JOHN GRACE ARMS

21030 Indian St. Southfield, MI 48033

EXISTING ROOF FRAMING PLAN

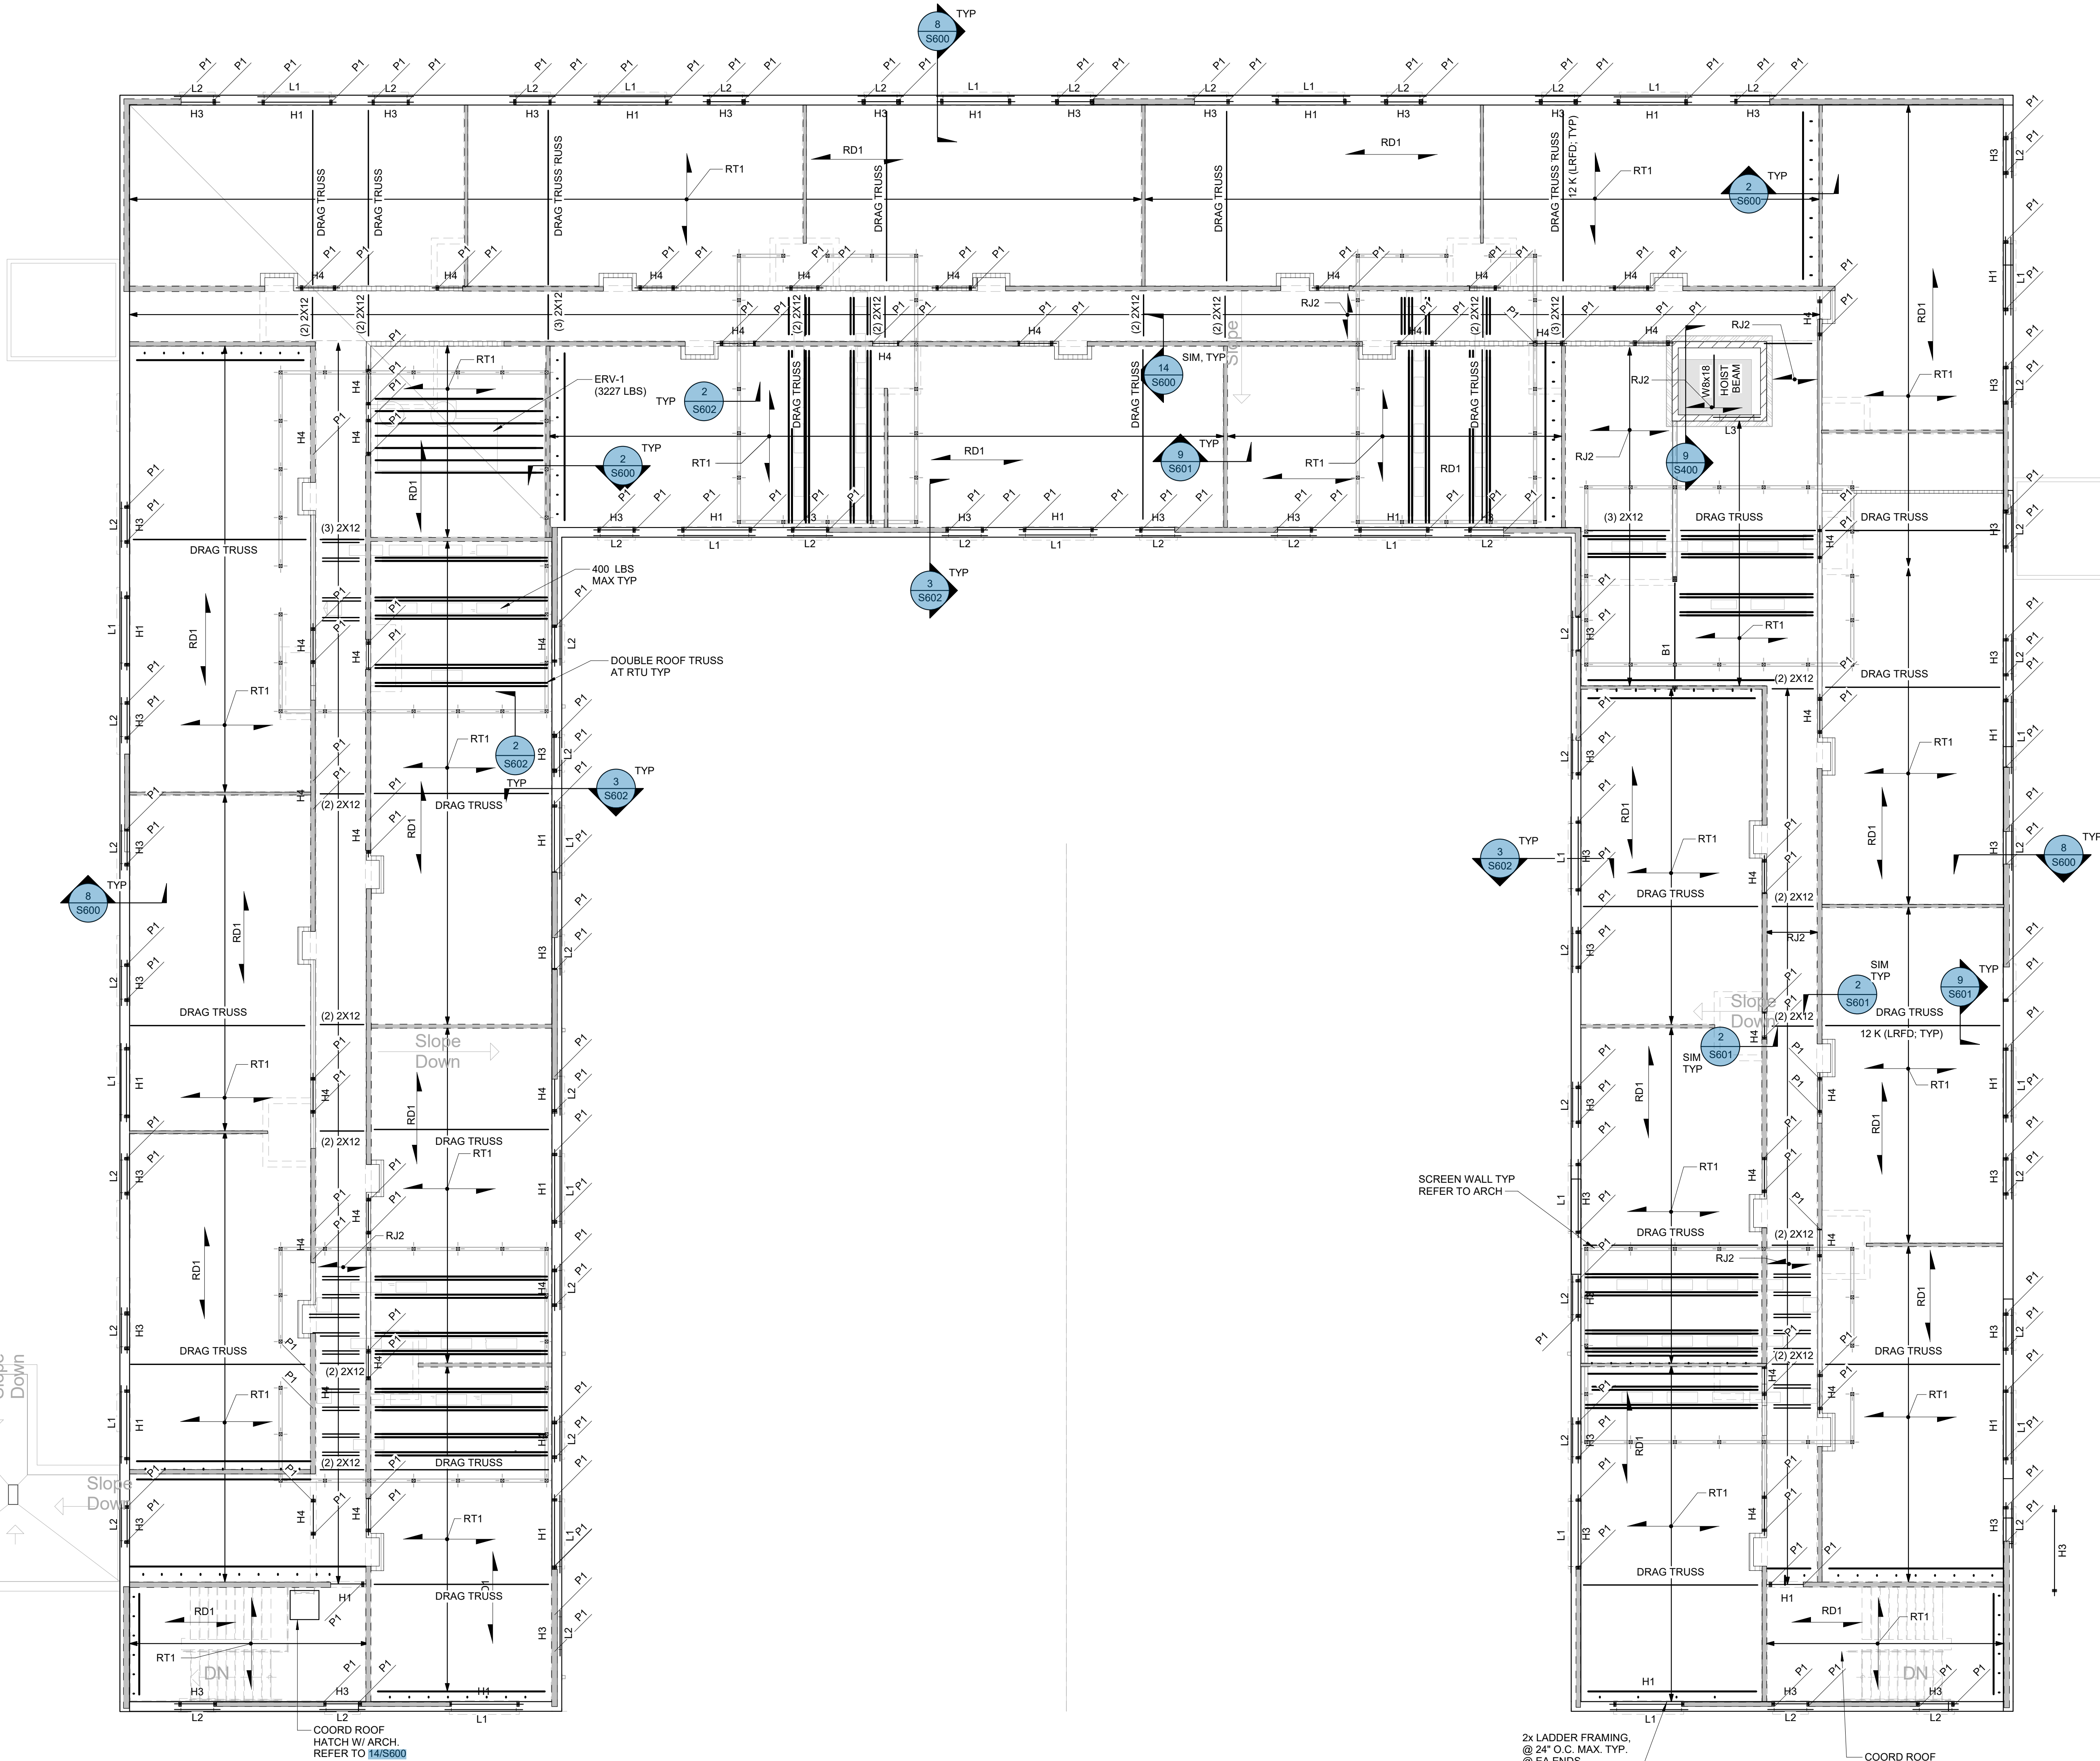
Dens Deck has been removed

RFI #76
